SUNDRY NOTICES AND REPORTS ON WELLS	
(DO NOT USE THIS FORM FOR PROPOSALS TO DRILL OR DEEPEN OR PLUG BACK TO A DIFFERENT RESERVIOR. USE "APPLICATION FOR PERMIT" (FORM C-101) FOR SUCH PROPOSALS.)

1. Type of Well: Oil Well <input type="checkbox"/> Gas Well <input checked="" type="checkbox"/> Other	WELL API NO. 30-025-09247
2. Name of Operator Apache Corporation	5. Indicate Type of Lease STATE <input checked="" type="checkbox"/> FEE <input type="checkbox"/>

3. Address of Operator 303 Veterans Airpark Lane, Ste. 3000, Midland, TX 79705	6. State Oil & Gas Lease No. B-1506
4. Well Location Unit Letter H A : 3650 feet from the N line and 990 feet from the E line Section 3 Township 23S Range 36E NMPM County LEA	7. Lease Name or Unit Agreement Name Sinclair "B" State

LEASE NAME SINCLAIR B STATE

WELL BORE INFO.

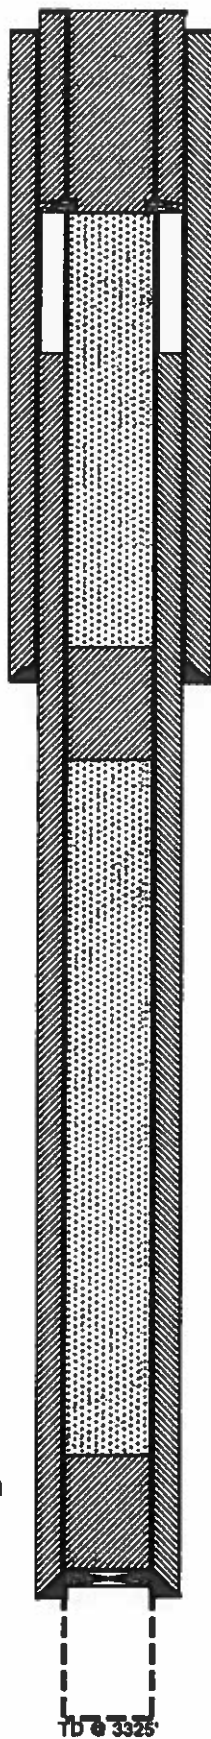
SEE ATTACHED
CONDITIONS OF APPROVAL

APPROVED BY: M. W. Fortner TITLE P.E.S. DATE 08/22/2018

Cut off wellhead 3' below ground level. Verify cement to surface. Install P&A marker.

3. PUH & perf @ 250', Sqz 75 sx Class "C" cmt from 250' to surf. Attempt to CIRC 5 1/2" to surf. (Water Board)

2. PUH & spot 25 sx Class "C" cmt from 1380'-1130', WOC/TAG (Surf Shoe & Top of Salt)

1. MIRU P&A rig / RIH & set CIBP @ 3000'. RIH w/ tbq & CIRC w/MLF & spot 25 sx Class "C" cmt from 3000'-2750' (Yates & Base of Salt)
